**RE: Mercy Hospital – Final CO Phase 1
Follow-up including amendment re Service Area Access**

**RE: Mercy Hospital – Amendment to Approved Site Plan: Service Area Gate and Access Area
Vicinity of Fore River, Portland ME (201 Fore River Parkway)**

**Subject: Mercy Hospital – Fore River Site Project Amendment
 Service Area Gate and Metal Building Berm
 Summary of Meeting**

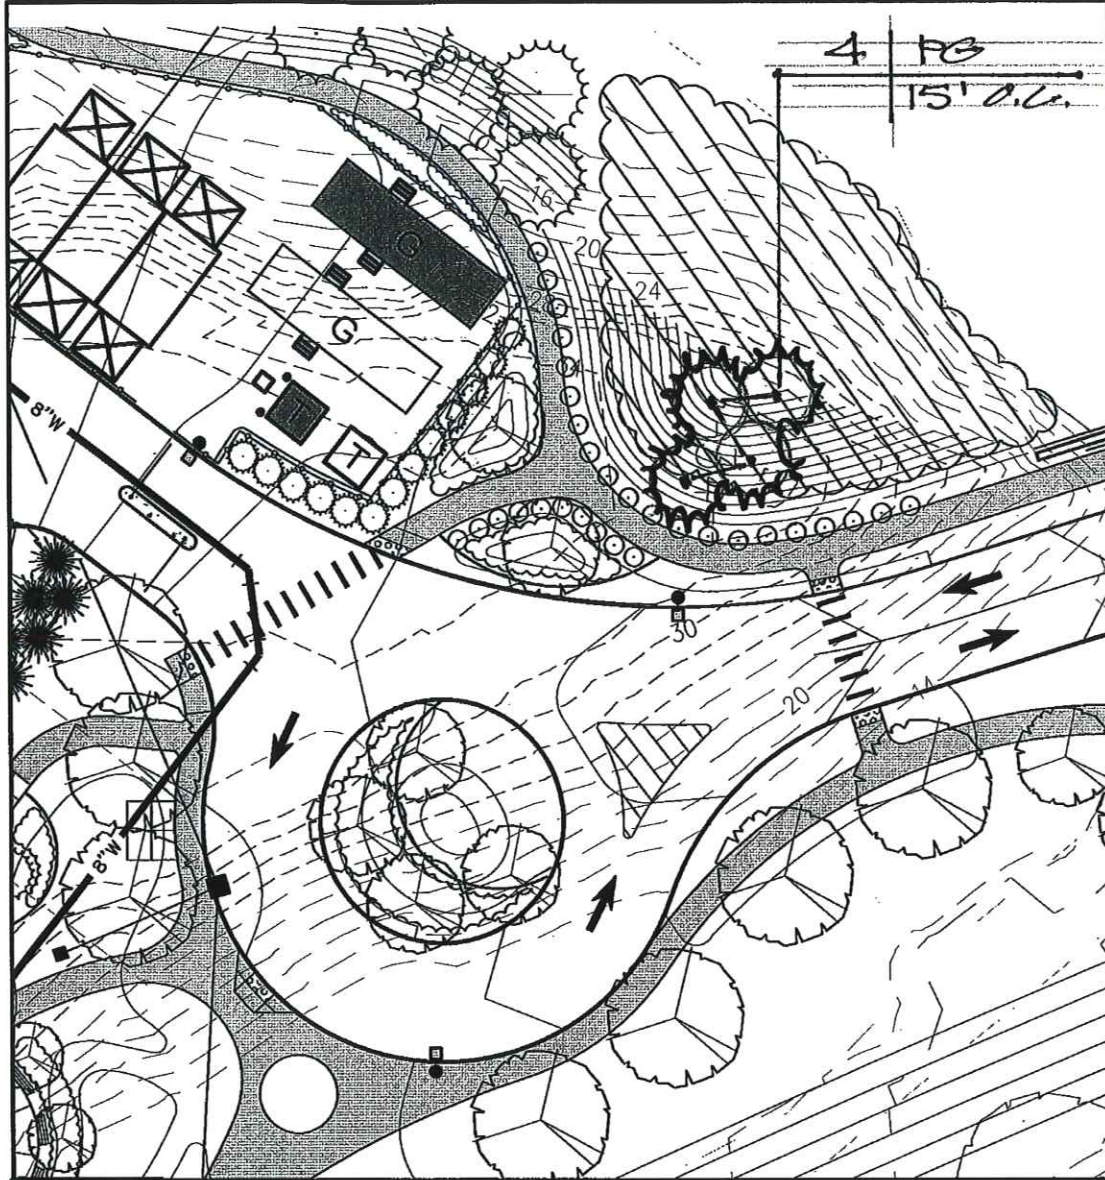
The attached sketch depicts where I propose the location of 4 new White Spruce per our discussion at City Hall last Friday, and my subsequent site visit. As I looked at the cooling equipment from various angles, it appeared that the location I've chosen provides the longest duration screening impact; ie., for someone approaching from the southeast on Fore River Parkway. I looked at it from the opposite direction, approaching from the northwest, too, and this approach could be characterized as having a shorter angle of view and view duration to the cooling equipment than the approach from the southeast. Plantings placed to screen view from this direction would simply not fit in with the overall design, and the screening would be less effective than where I propose. Ultimately, as discussed in our meeting, the area between the Parkway and mechanical farm will become more planted, not less, as the gardens and plantings in this area evolve and mature.

1. Jeff approves the screen design concept sent on 11-19-08 for the service area of the hospital. With that, we will formalize with the contractor for installation in the spring, earlier if possible.

SCALE Service Area gate control - N.T.S

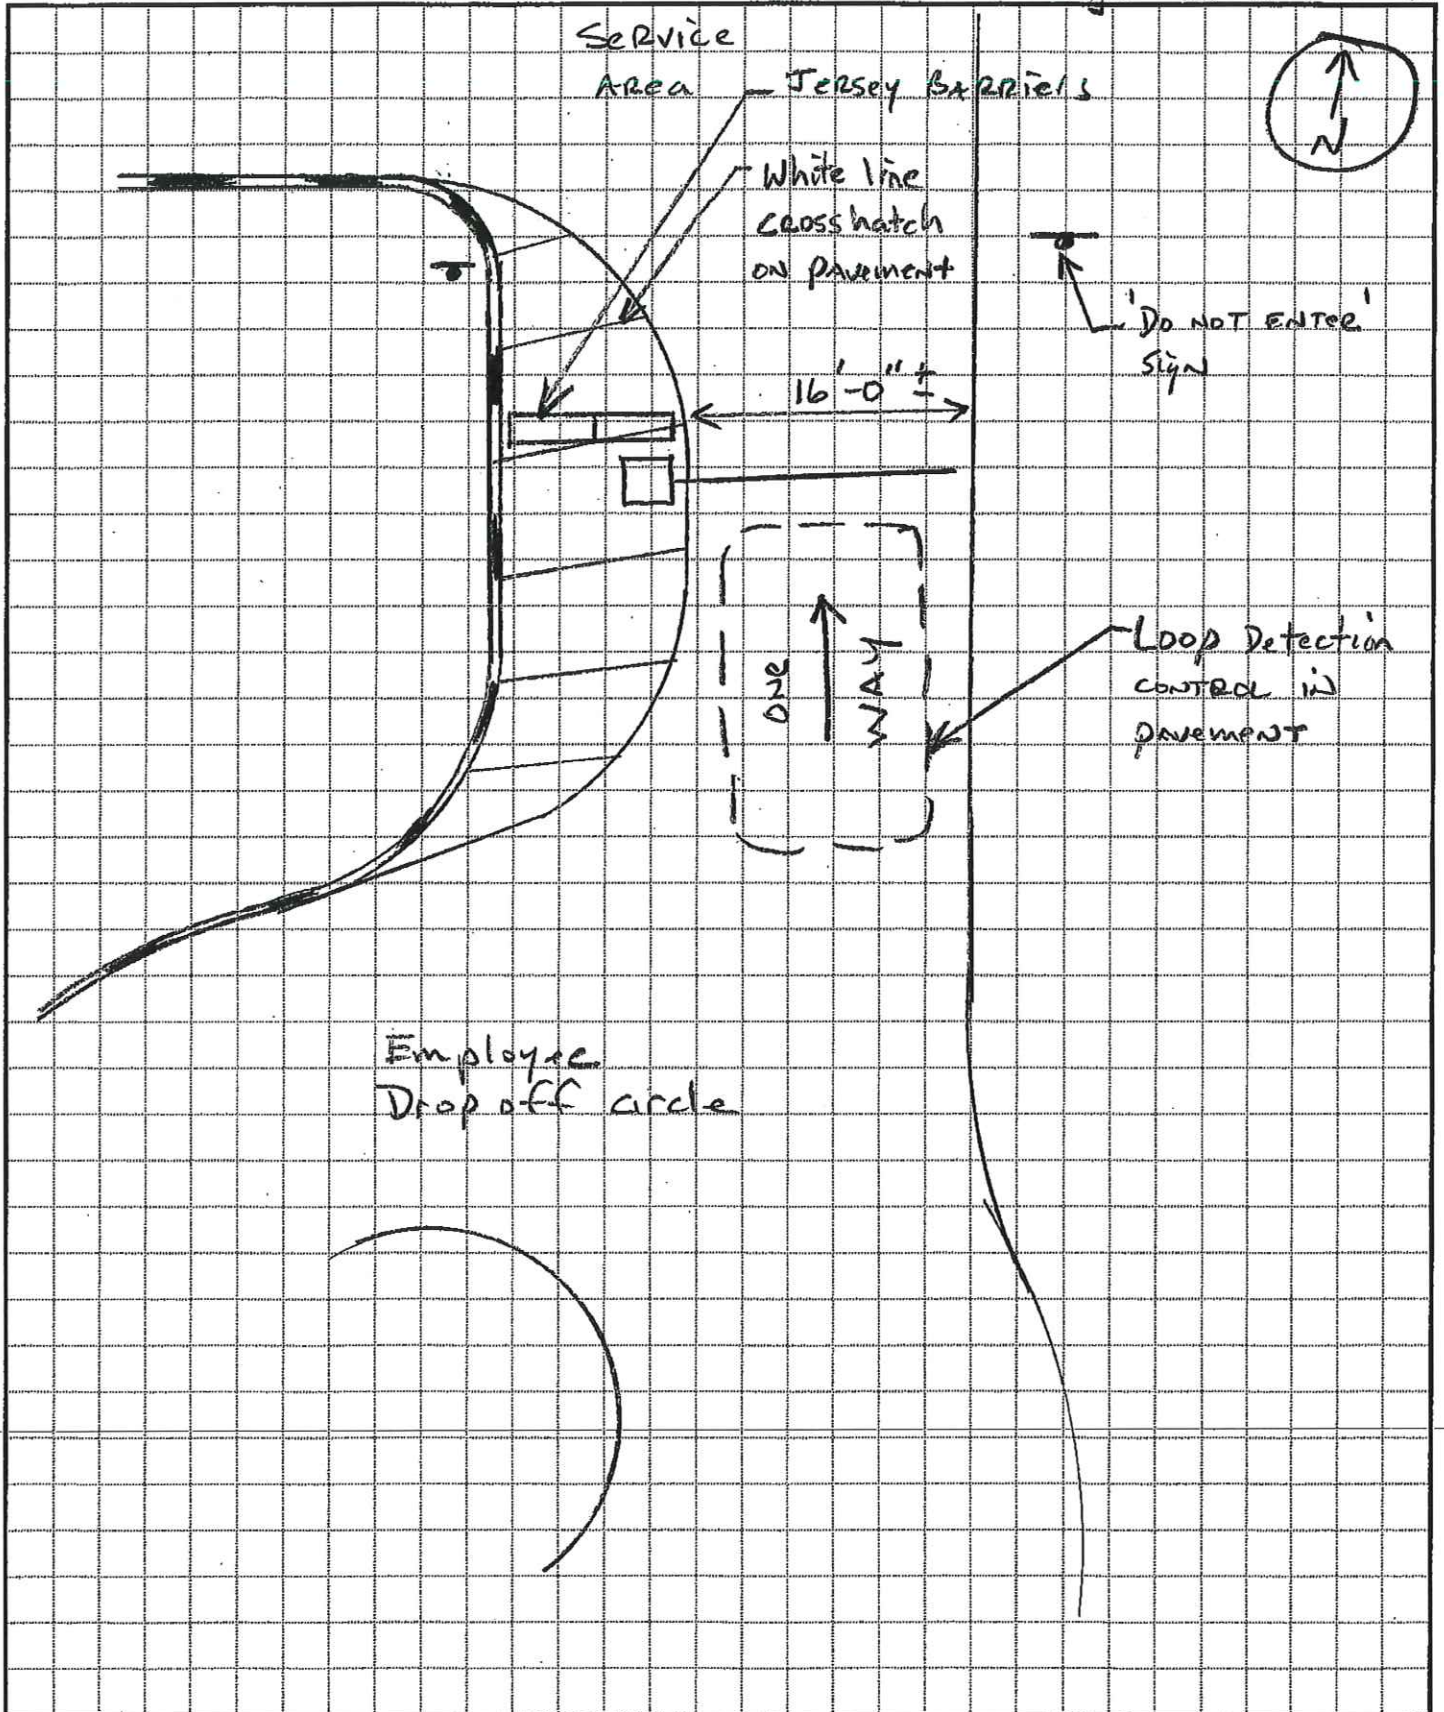
Mercy is proposing to install a gate control at the service area entrance off their circular drop off near the rear of the hospital. The attached sketch shows the basic configuration. The drive width will be reduced to 16 feet by placement of jersey barriers across half the existing drive aisle. The jersey barriers will also provide protection to the gate box. The attached figure only shows barriers on one side. We have decided to place them on both sides of the gate box. They think they can have this installed by the end of the week. Please review and let me know if this meets your expectations based on the phone discussion you and I had.

<p>DeLuca-Hoffman Associates, Inc. 778 MAIN STREET, SUITE 8 SOUTH PORTLAND, ME 04106 207.775.1121 WWW.DELUCAHOFFMAN.COM</p>	DRAWN: DED DATE: 10.30.08	FIGURE <h1>CSK-34</h1>
	DESIGNED: SRB SCALE: 1" = 40'	
	CHECKED: SRB JOB NO. 2149.01	
	FILE NAME: 2149.01-MP3

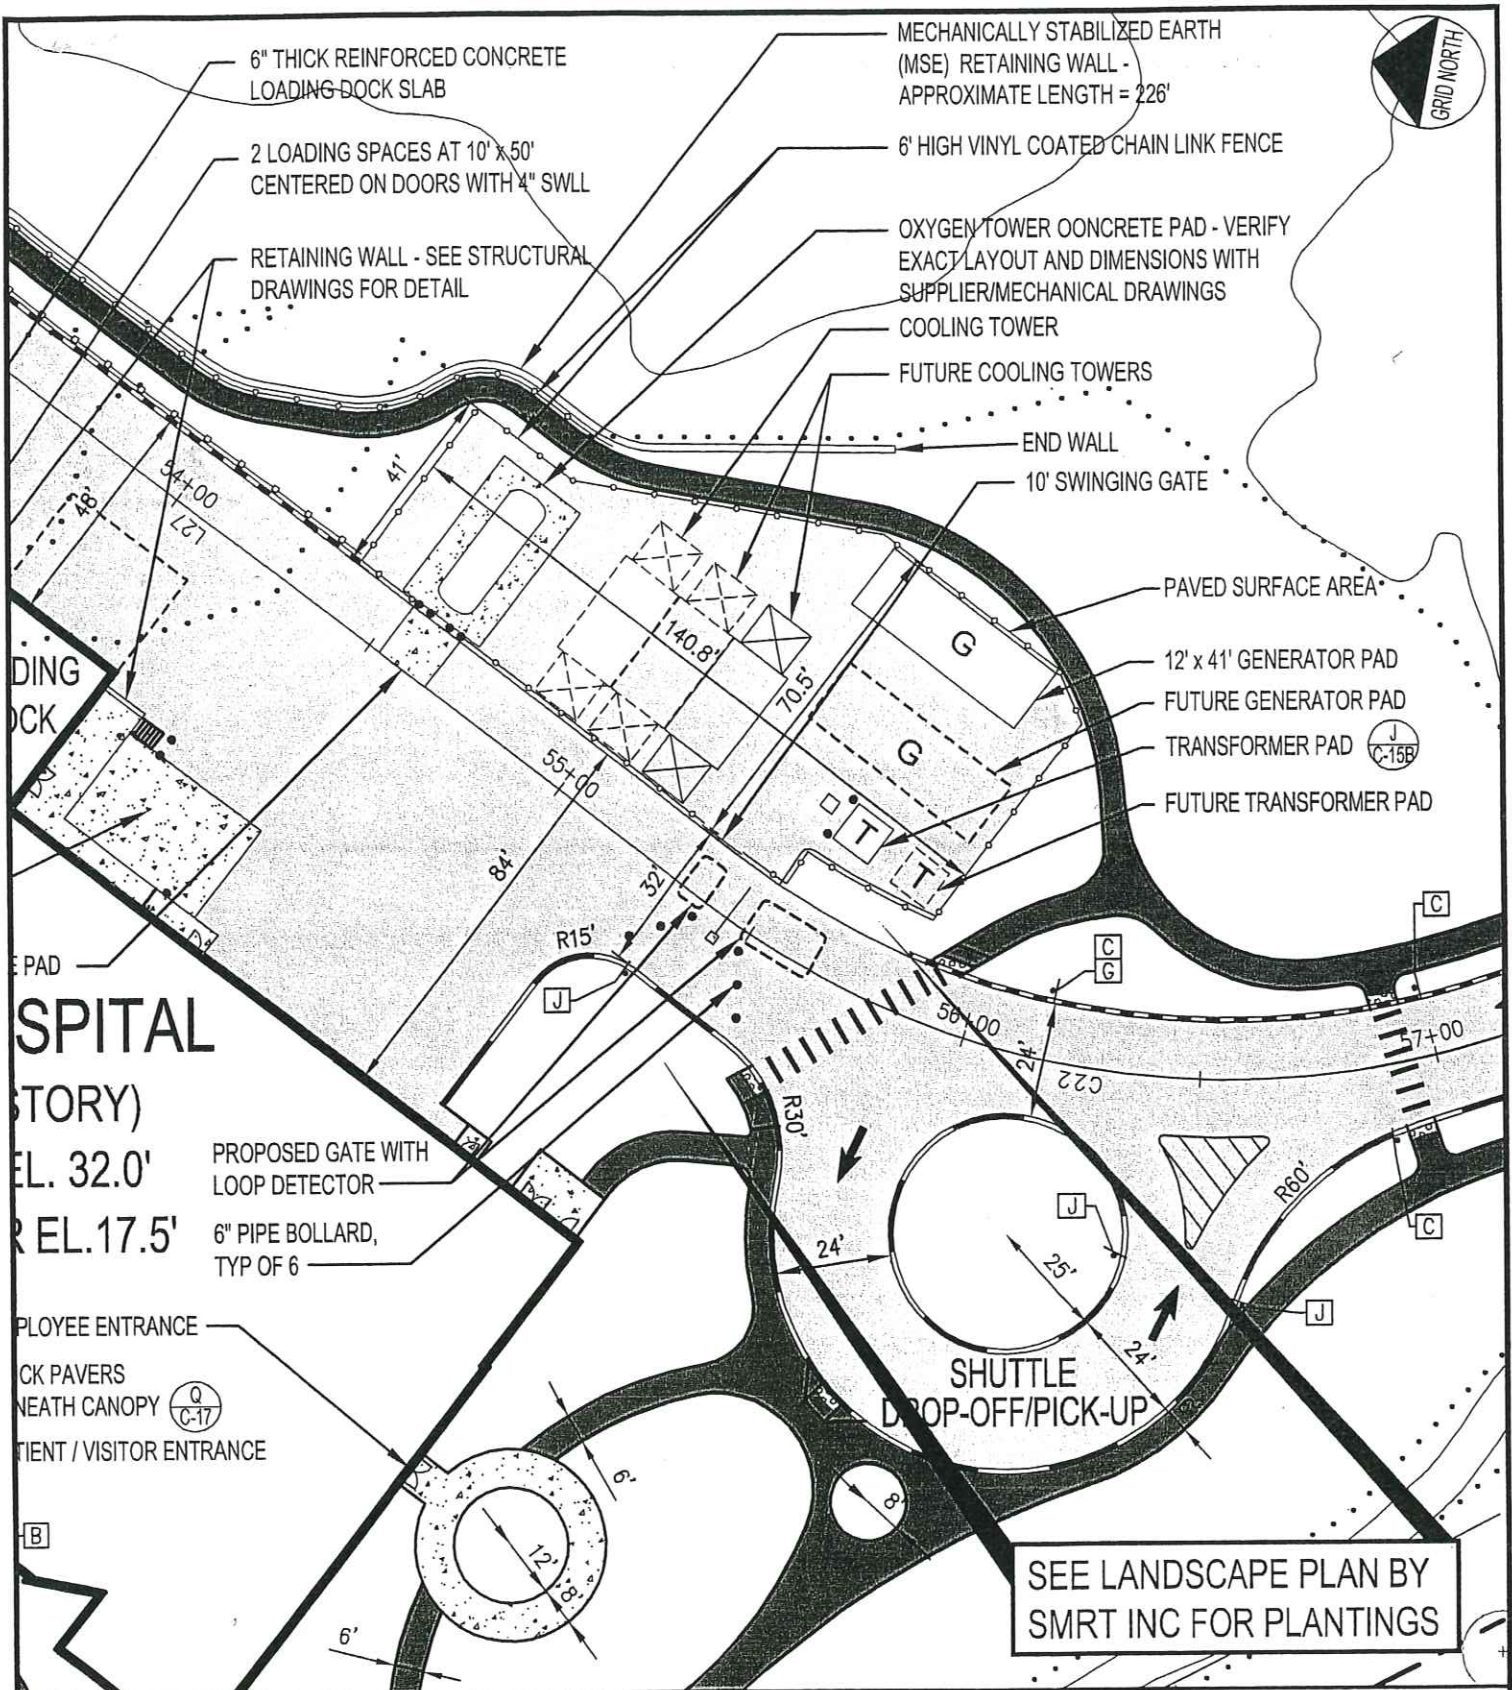
As a follow-up to our meeting on Friday, November 14, 2008, we are reaffirming Mercy's proposal related to the installation of a control gate at the service area entrance off the employee drop-off circle near the southeast corner of the Hospital. As we discussed, Mercy will install a controller box and gate within the existing paved area as depicted on the attached figure. Mercy will also install multiple 6" pipe bollards on each side of the control box to provide for its protection. Mercy does not plan to make any revisions to the existing curb alignment in this area. The gate will be controlled by loop detectors in the pavement on each side of the gate. The detector on the south side of the gate will open the gate and the detector on the north side will close the gate.

We understand, based on our discussions, that the City has also approved the placement of black vinyl slats in the chain link fence that faces the building adjacent to the transformer pads and cooling tower. Finally, Mercy agrees to install four evergreen plantings in the front yard area to improve screening of the cooling tower. The exact location will be coordinated with Jeff Tarling of the City's Parks and Recreation Department next spring.

On November 21, 2008, the Portland Planning Authority approved the amended site plan for the Phase 1 Mercy development, to include installation of a gate (controlled by loop detectors) and six bollards at the entrance to the service area of the main hospital building near the Fore River Parkway, as shown on the approved plan CSK-34 dated October 30, 2008 and as amplified in the letter of November 17, 2008 from DeLuca Hoffman Associates Inc, with the following conditions:

1. That black vinyl slats shall be placed in the chain link fence around the transformer pads and cooling tower; and
2. That four evergreen trees shall be planted in the front yard area to improve screening of the cooling tower; the location and species/size of such planting to be reviewed and approved by the City Arborist Jeff Tarling.
